THE CLEVELAND ELECTRIC ILLUMINATING COMPANY

PY-CEI/NRR-0259 L

Perry Nuclear Power Plant
Docket Nos. 50-440; 50-441
Containment Bypass Leakage
(Questions 480.49-480.51,
License Condition 16)

FIGURE 1 REACTOR VESSEL ELEVATIONS

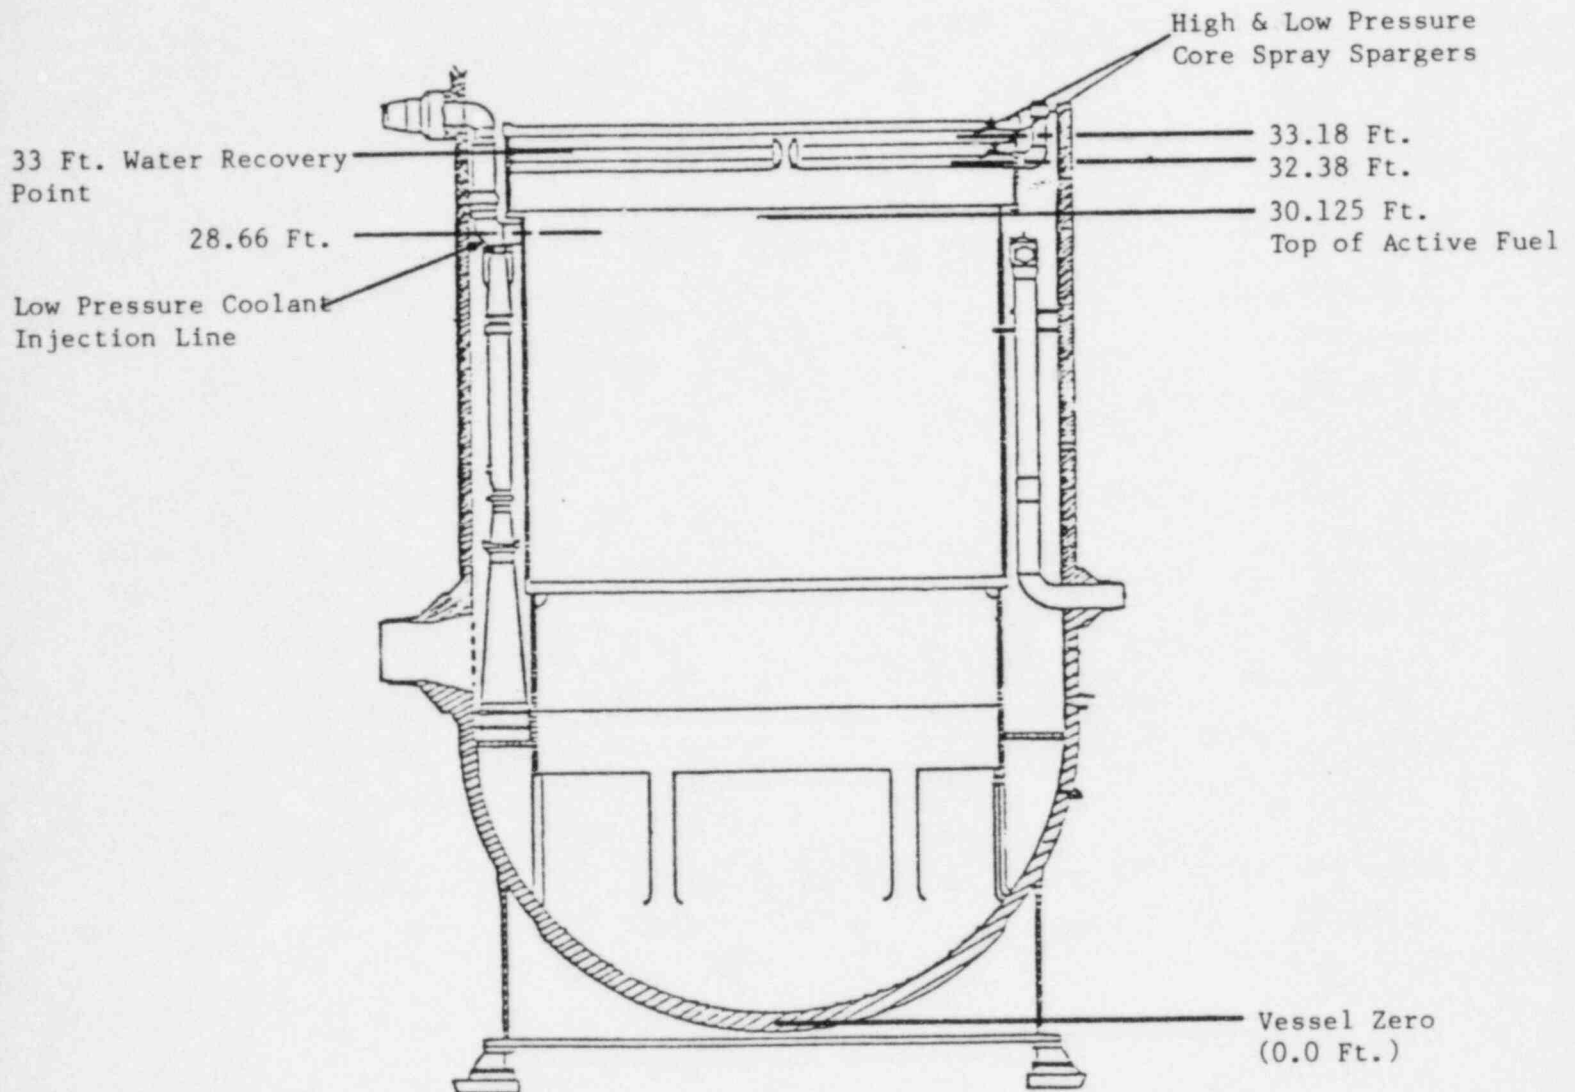
Failure of an ECCS or RCIC line water seal could cause draining down of the line such that an air leakage path could exist which was not identified by the NUREG 0737 testing. These lines are not a source of air bypass leakage for the following reasons:

The attached Figure 1 shows vessel elevations of the high and low pressure core spray spargers, the low pressure coolant injection line, the top of active fuel, and the minimum water level recovery point as shown on FSAR figures in Chapter 6.3. Note that the water level recovery point is above the LPCI injection point, but at or below the core spray spargers. The RCIC line injects through the vessel head and is therefore above the water level recovery point. The maximum time for water level to reach the recovery point is about 16 minutes (FSAR Figure 6.3-69).

For LPCI A, B, and C injection lines (penetrations P113, P412, and P411) the concern is whether air leakage could occur through the injection valves during the 16 minute period the LPCI injection line in the vessel remains uncovered by water. Prior to the accident, the injection lines inside containment will be water-filled. At the initial depressurization caused by the LOCA, some of the water in the lines will flash to steam. The remainder of the water would have to leak through the closed injection valves before the valves would leak air into the closed systems outside containment. Based on the pipe lengths and amount of water in the lines post-LOCA, the injection valves would have to leak excessively (greater than 10 gpm) to eliminate the water seal in the 16 minute period the LPCI lines are exposed to vessel atmosphere. Per Perry's Technical Specifications, the injection valves are limited to 1 gpm leakage. Therefore, even if the waterleg pumps fail and the systems become inoperable, the LPCI A, B, and C injection lines will not leak air post-LOCA and will not be sources of air bypass leakage.

HPCS and LPCS spargers discharge into the reactor vessel above the water level recovery point, therefore, assuming an inoperable system and a water leg pump failure, air could leak into these closed systems outside containment. Several barriers, however, will prevent air leakage to the atmosphere:
